# SERVICE BULLETIN

**Machines/Models:** X-Series  
Work Platforms

**SERVICE BULLETIN:** 94.9

**PURPOSE:** Notification of requirement to check wiring.

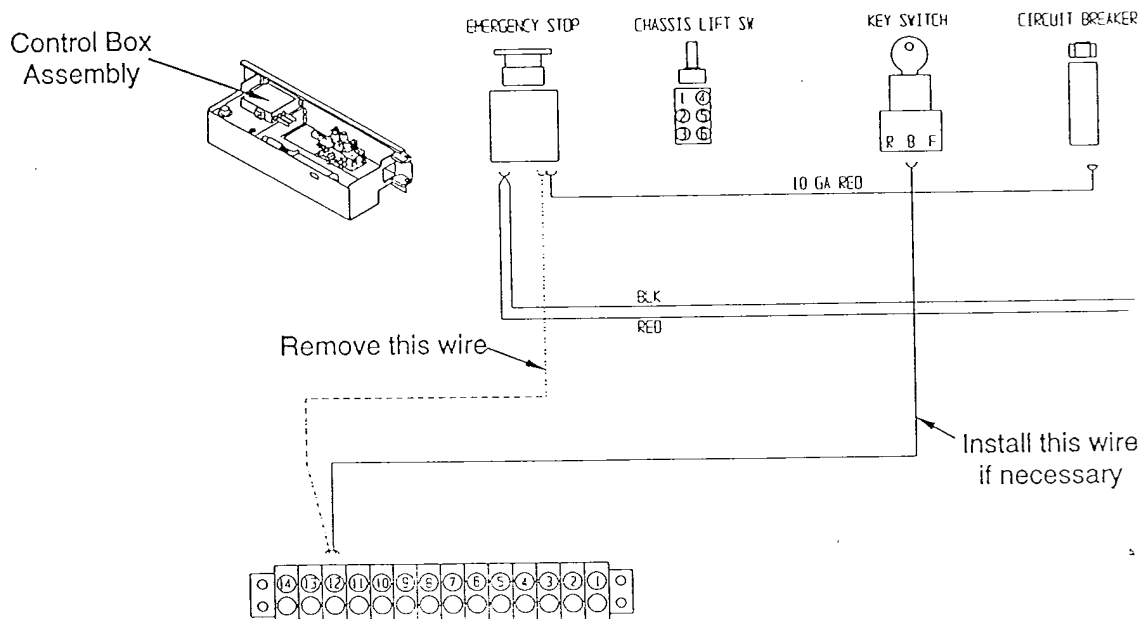
**OPERATION REQUIRED:** Check wiring per instructions and attached drawing to insure proper protection of wiring by circuit breaker.

- PROCEDURE:**
1. Push chassis emergency stop switch button down to OFF position.
  2. Open control module and remove cover from control box assembly.
  3. Inspect wires at emergency stop switch: One terminal will have 2-16 gauge wires, one red, one black. The other terminal will have one 10 gauge red wire. If no other wires are found inspection is complete. If there is another wire, trace to its destination. If this wire goes to terminal 12 on the electric box terminal strip, remove this jumper and replace with a 16 gauge jumper from terminal 12 to the center (B) pole of the key switch.
  4. Replace control box cover, close module and pull emergency stop switch button out to ON position. Operate the machine, testing each function to verify proper operation.
